Approved Section 4.55 (.....2.....) Modification Application

Project
BARANGAROO STAGE 1B
PUBLIC DOMAIN
Modification S4.55

Drawing Title
WATERMANS QUAY
DETAIL PLAN - TREES

Drawing Title
WATERMANS QUAY
DETAIL PLAN - NO TREES

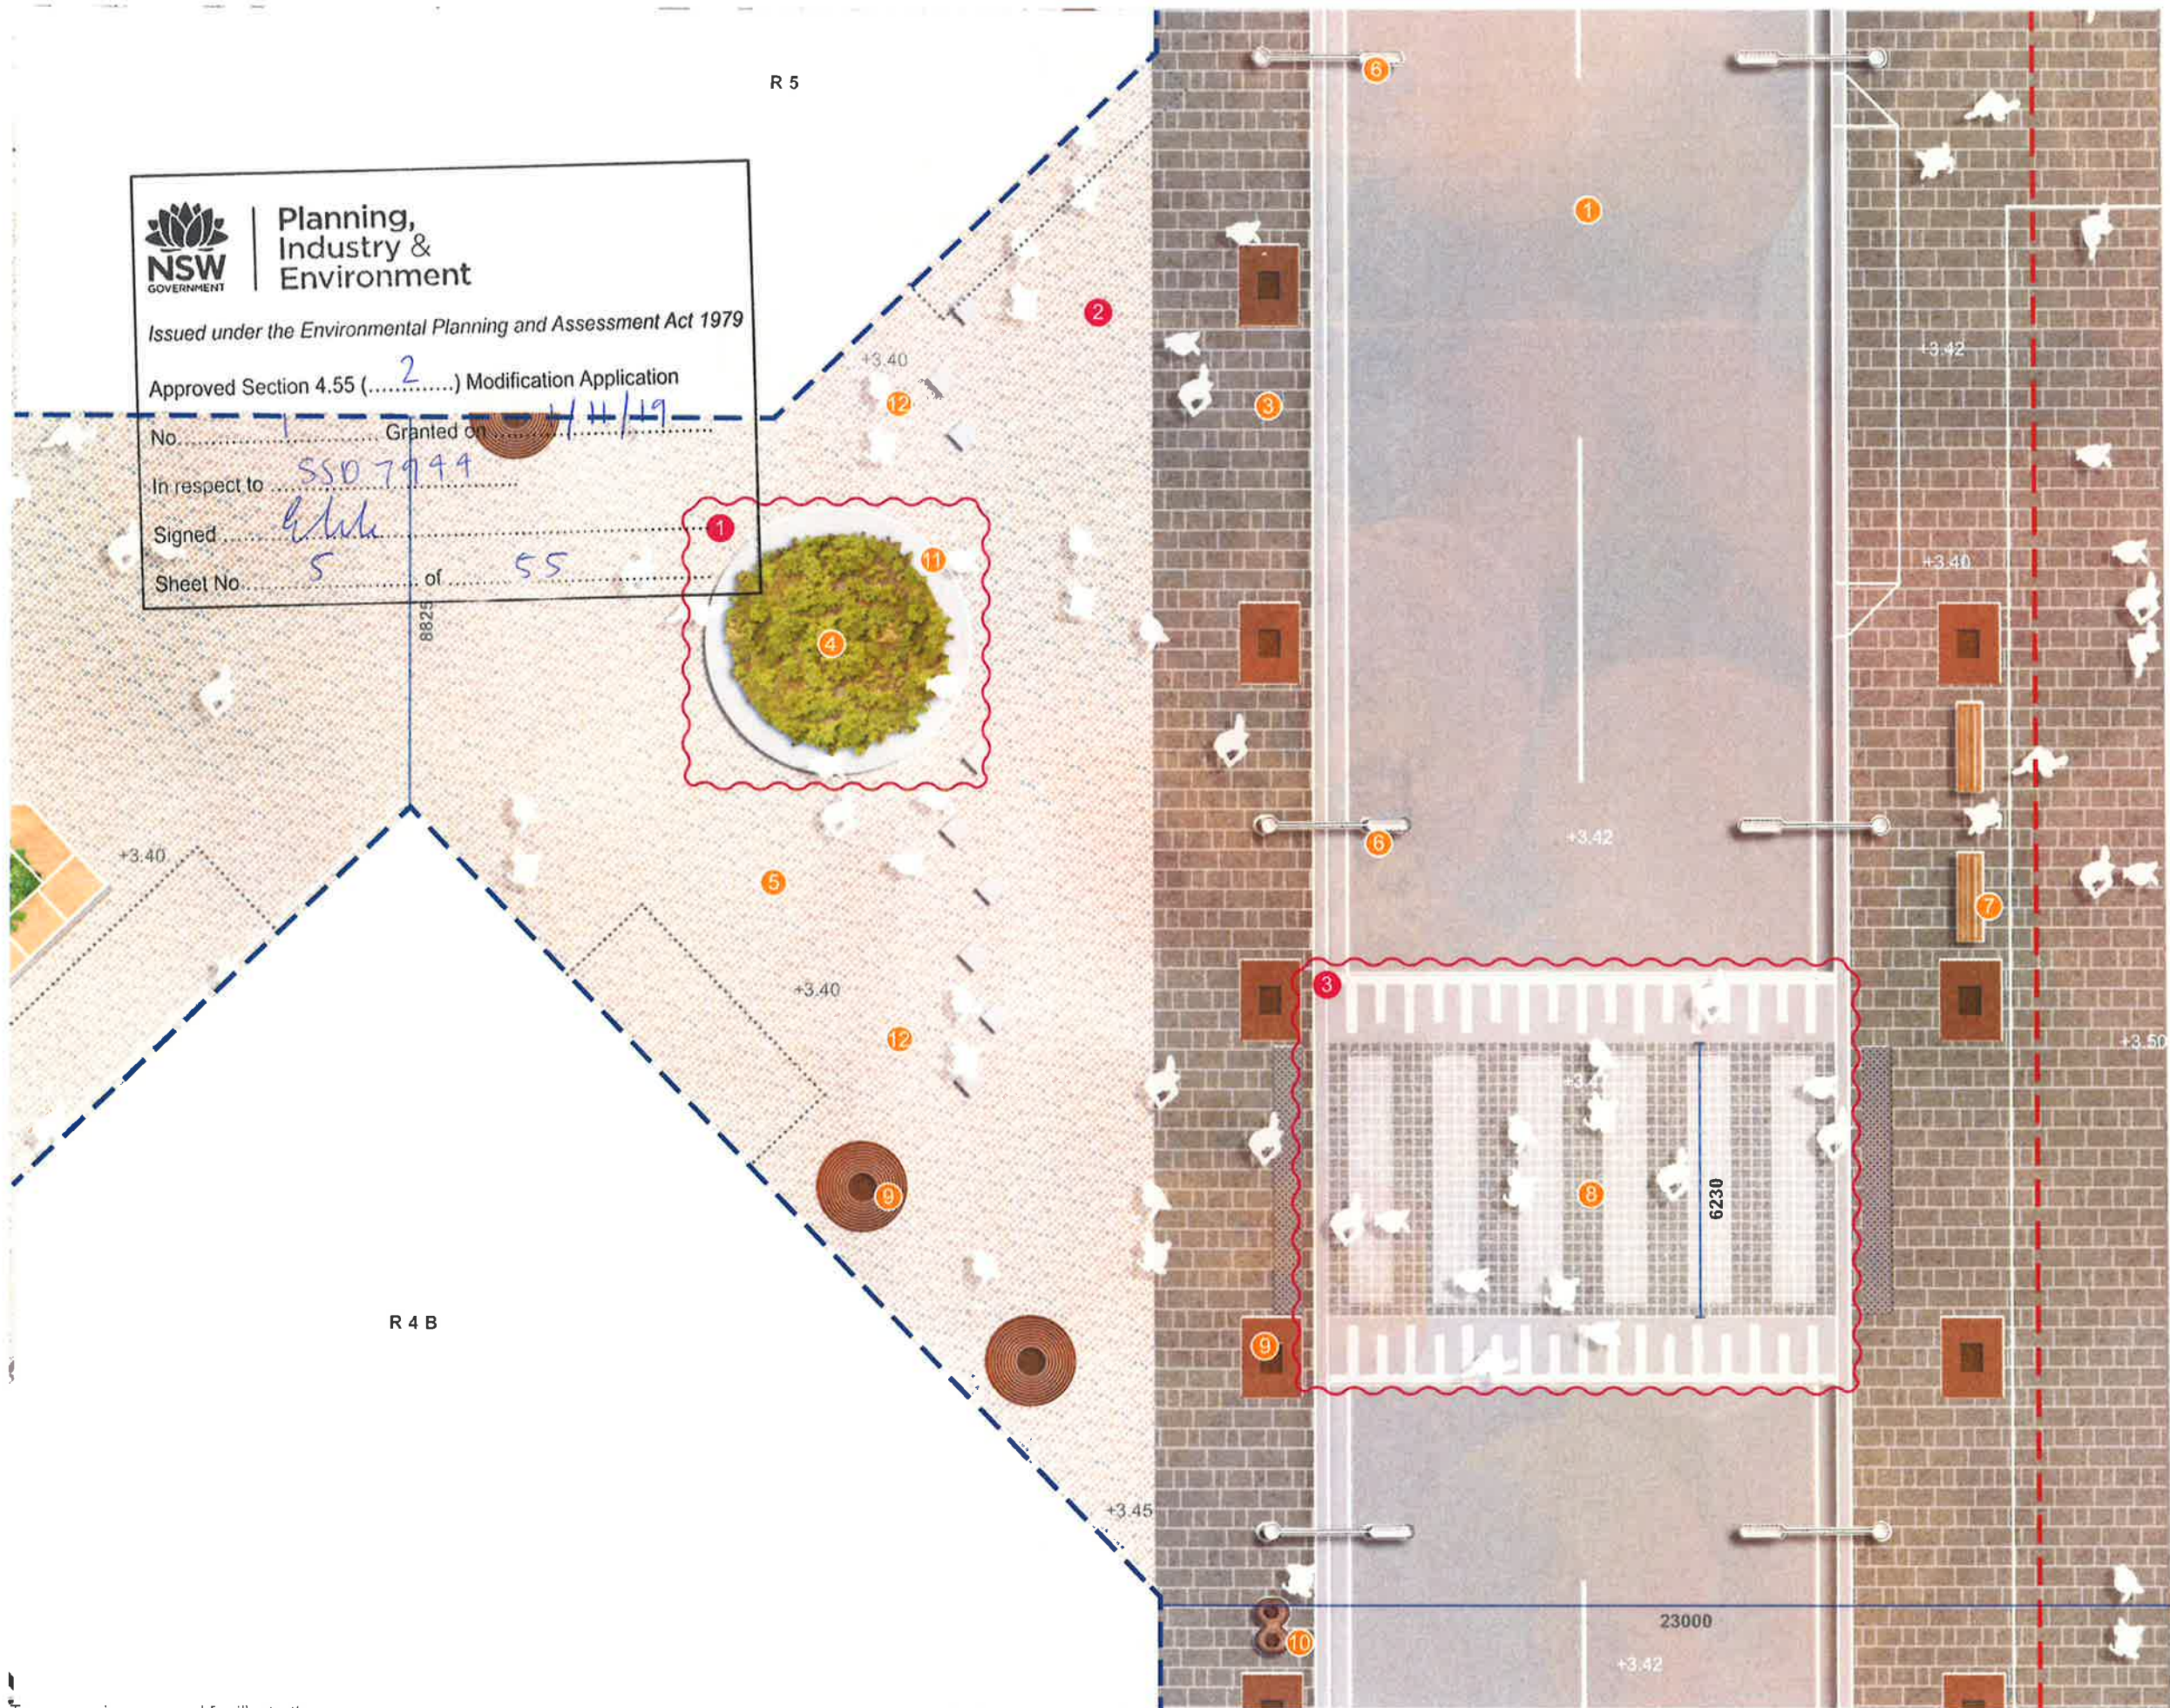
- Amendment cloud
- 1 Remove timber top for Watermans Quay raised planter seating
- 2 Remove porphyry paving to City of Sydney transition as per consent requirement B23
- 3 Reduce size of raised crossing

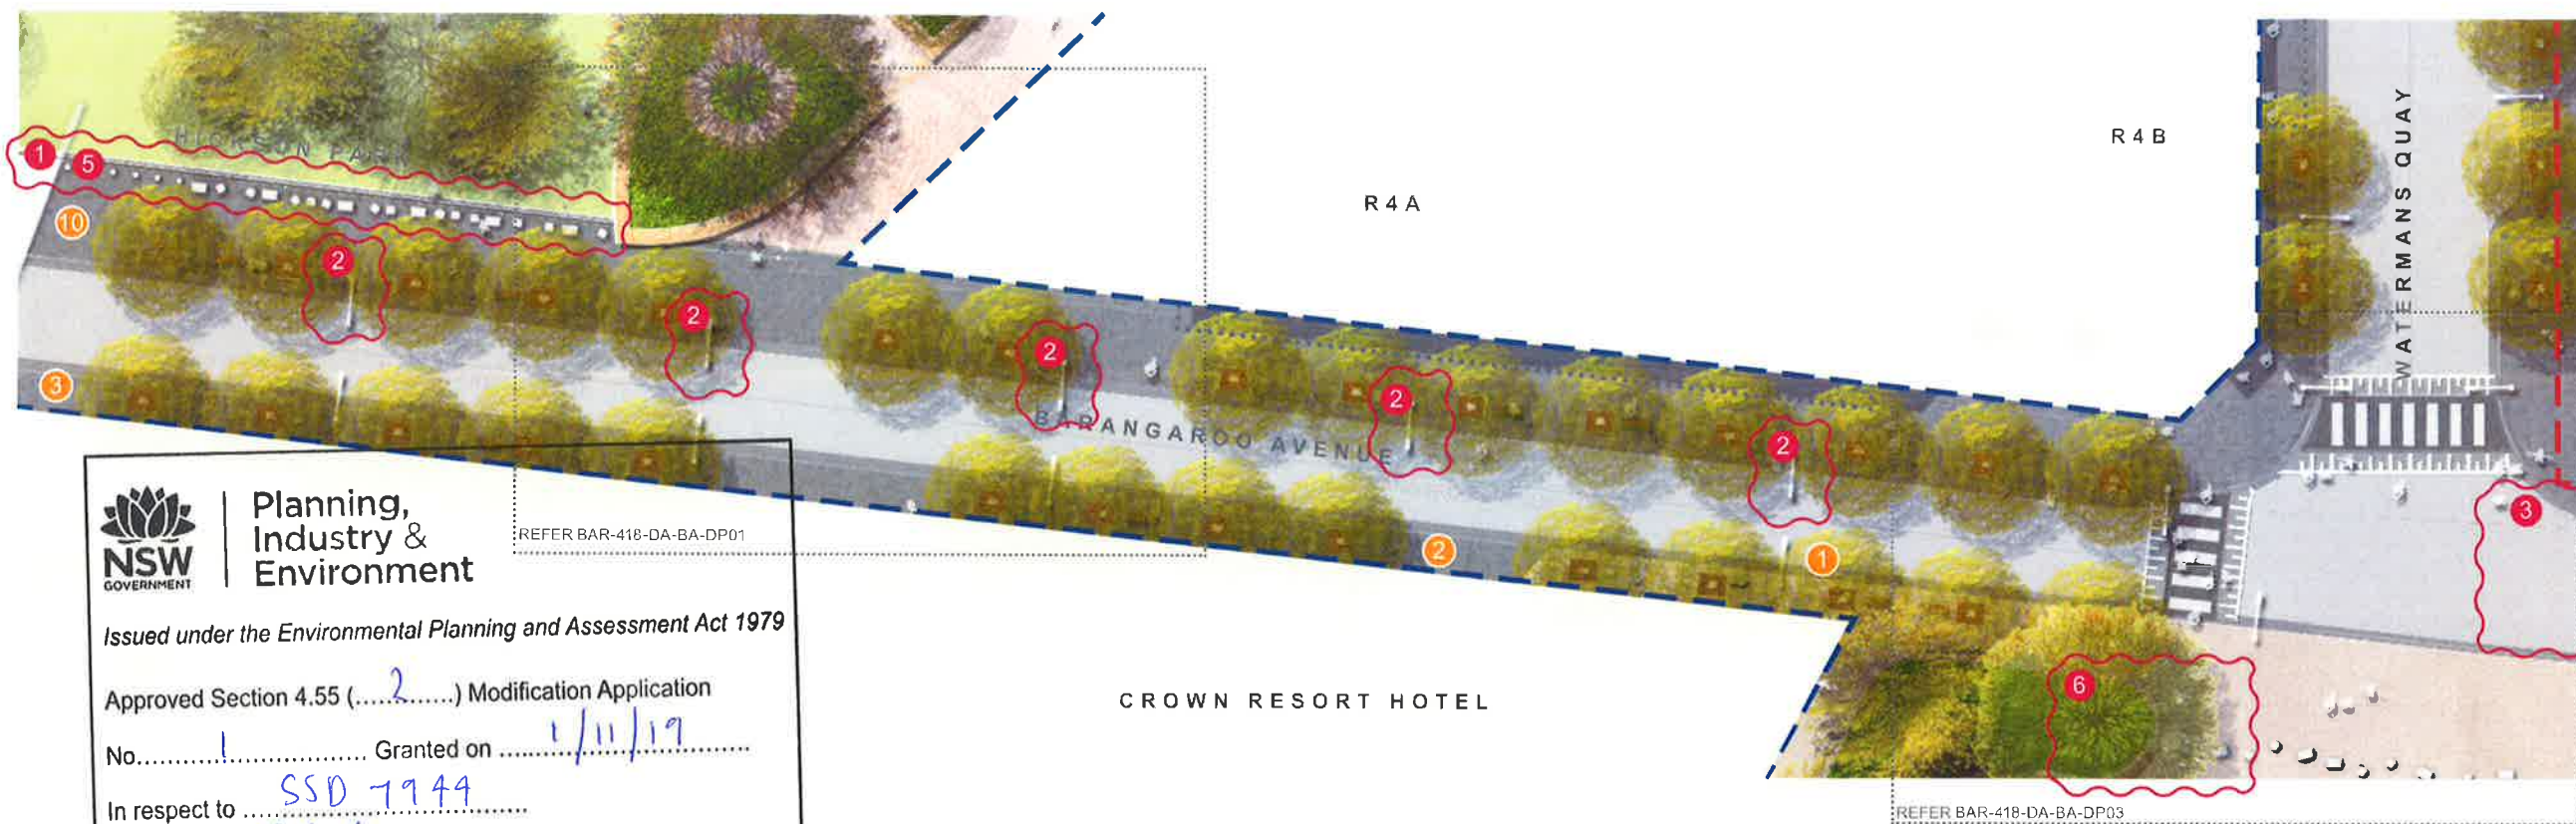
- Amendment cloud
- 1 Remove timber top for Watermans Quay raised planter seating

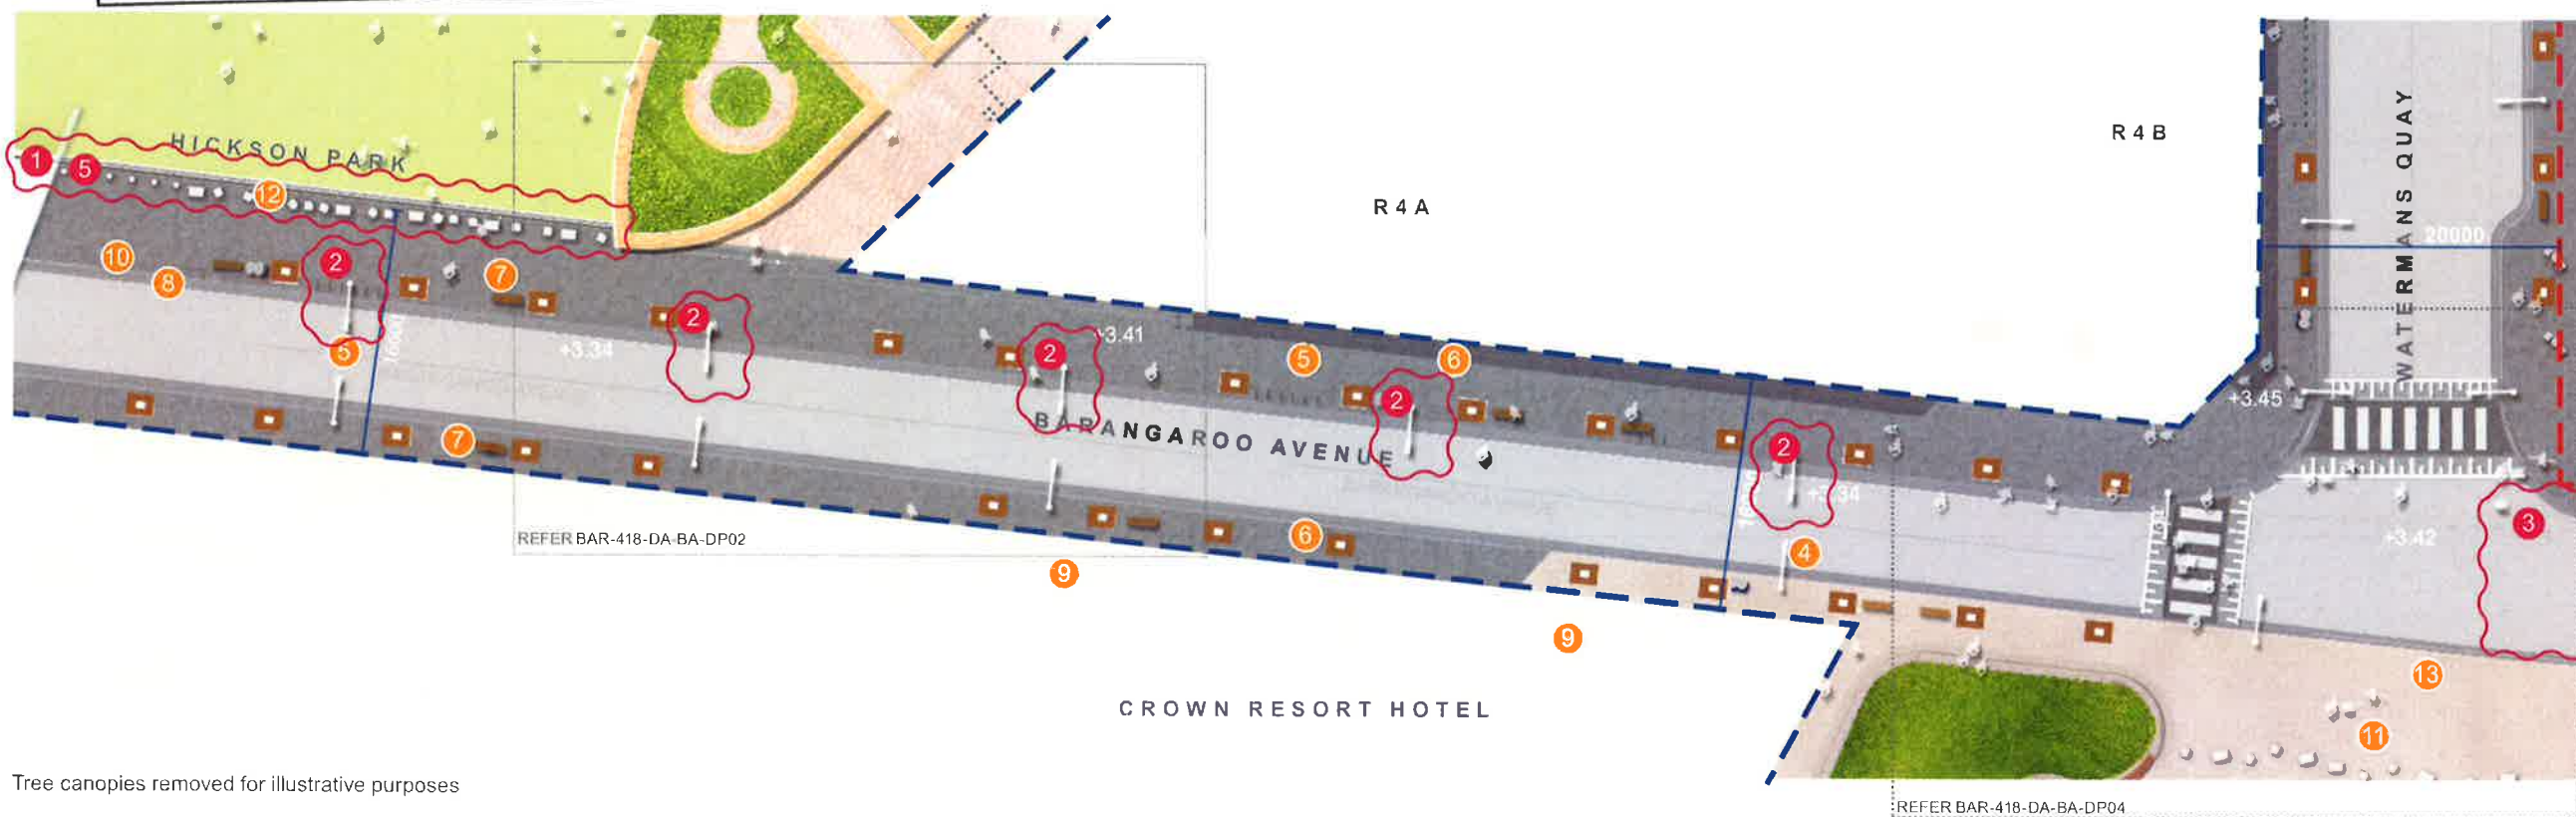
- Proposed Modifications**
- Amendment cloud
 - 1 Sandstone paving strip changed to City of Sydney paving along Hickson Park
 - 2 Additional smart pole
 - 3 Deletion of pedestrian crossing
 - 4 Not in use
 - 5 Sandstone bollards changed to concrete & setout amended.
 - 6 Relocated Fig tree to North raised planter
